SUBJECT: Abraham Lincoln Capital Airport
Springfield, Illinois
Sangamon County
Illinois Project Number: SPI-4635
SBG Project Number:
Contract No. CA020
Item No. 4A, April 27, 2018 Letting
Addendum A

NOTICE TO PROSPECTIVE BIDDERS

Addition of Power Duct Bank and Handholes to the electrical plans.

SUMMARY OF QUANTITIES BASE BID: ROADS AND PARKING LOT

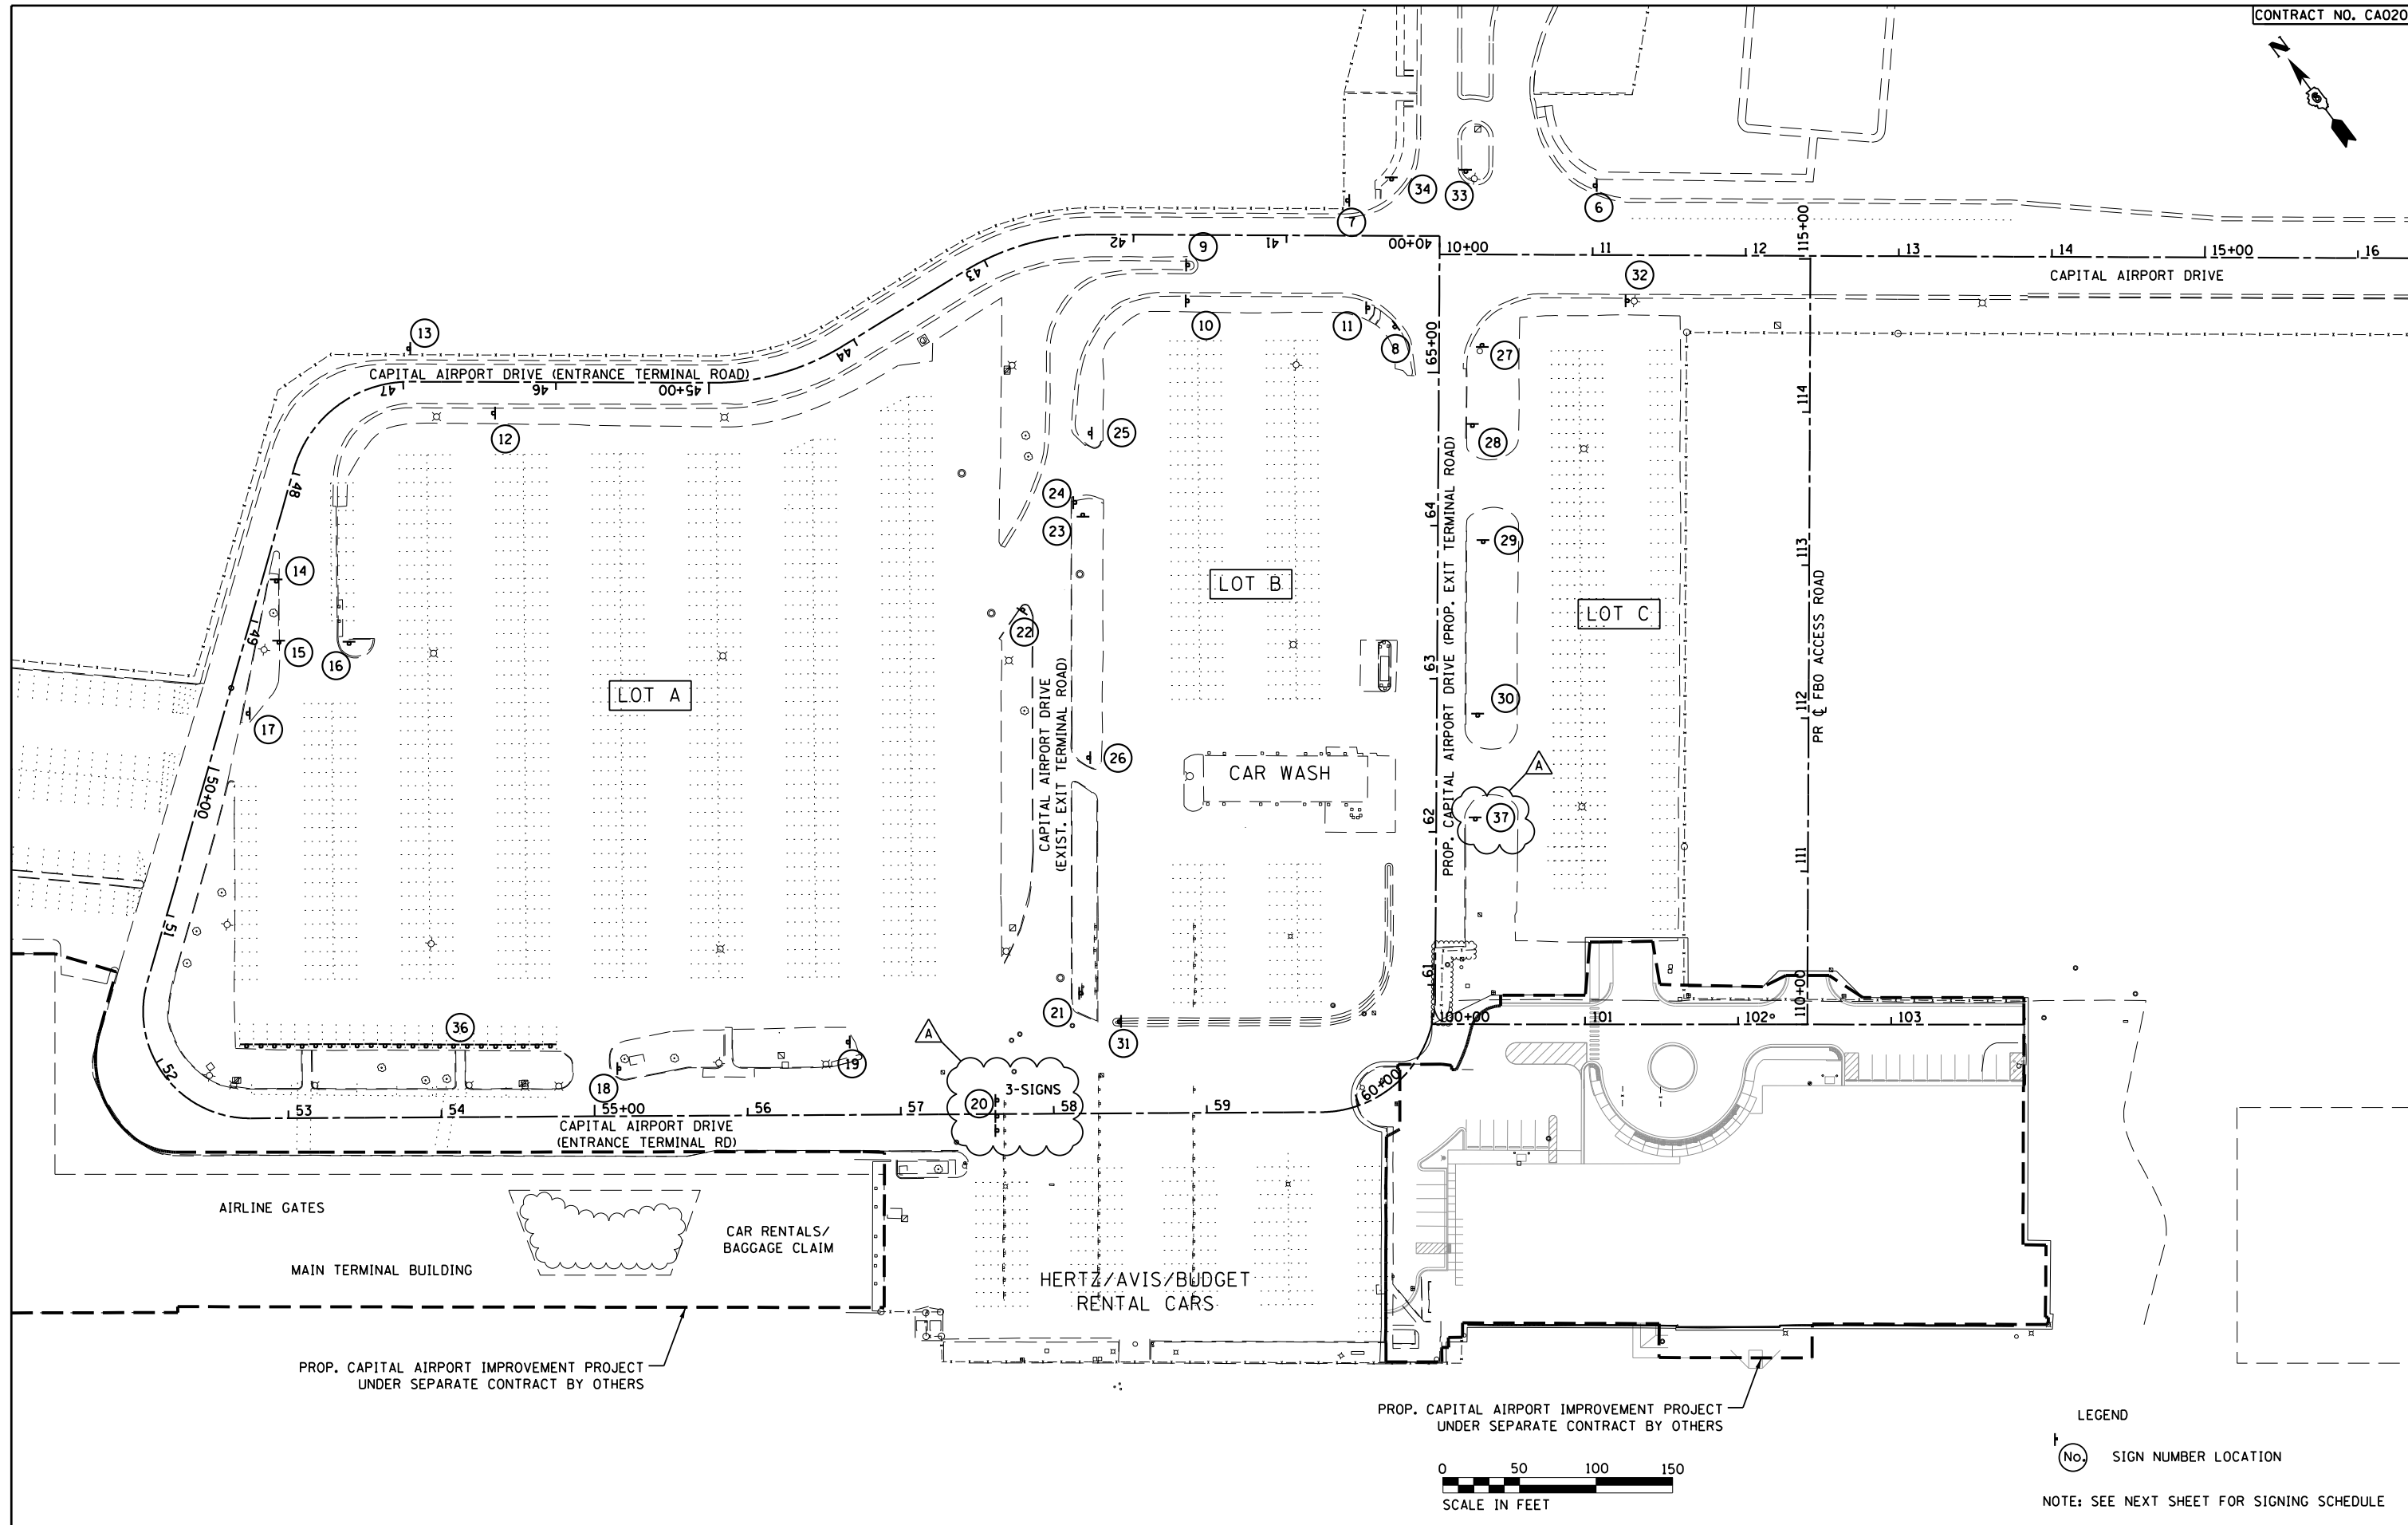
1. Plan Sheet 2
Added ITEM AR110504 4-WAY CONCRETE ENCASED DUCT LF
Deleted ITEM AR801601-REMOVE EXISTING LUMINAIRE, SALVAGE-EA
Revised quantities for ITEMS AR801667, AR910201, AR910915, AR910975, AR950110

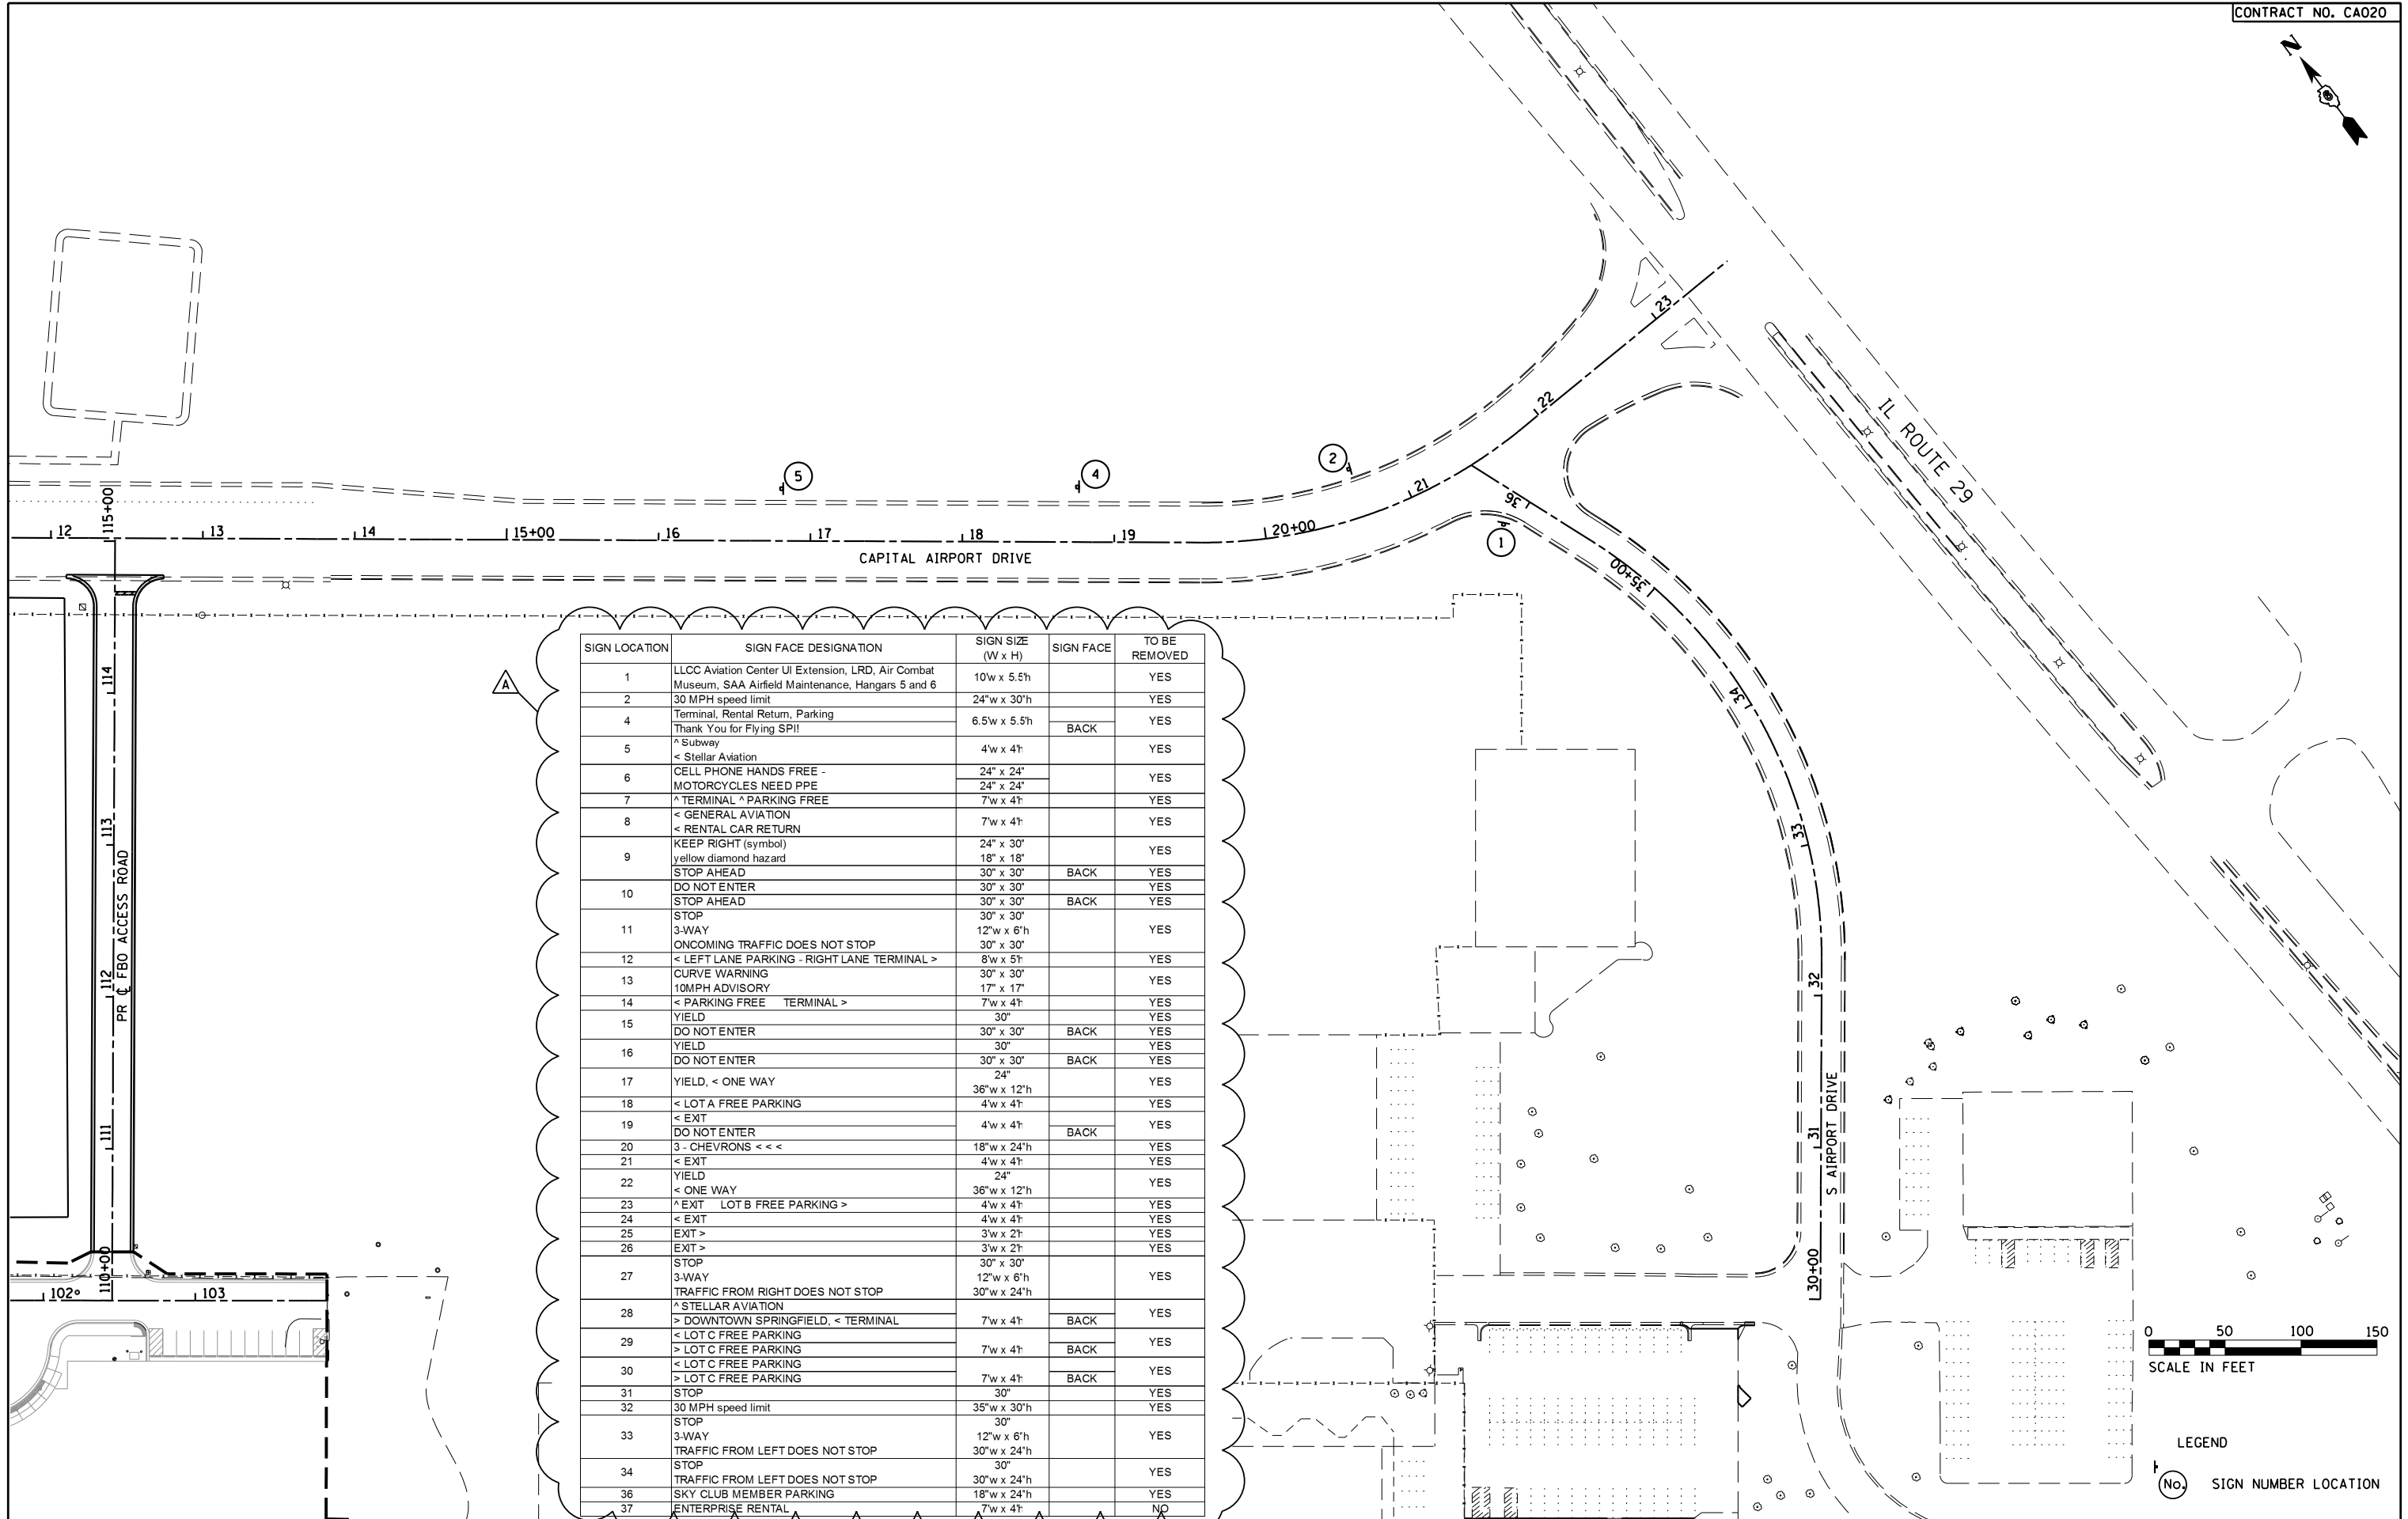
2. Plan Sheet 50-Modified note references as shown in clouded revisions.
3. Plan Sheet 51-Revised data inside table.
4. Plan Sheets 52-Revised notes in legend and callouts on plan sheet as shown in clouded revisions.
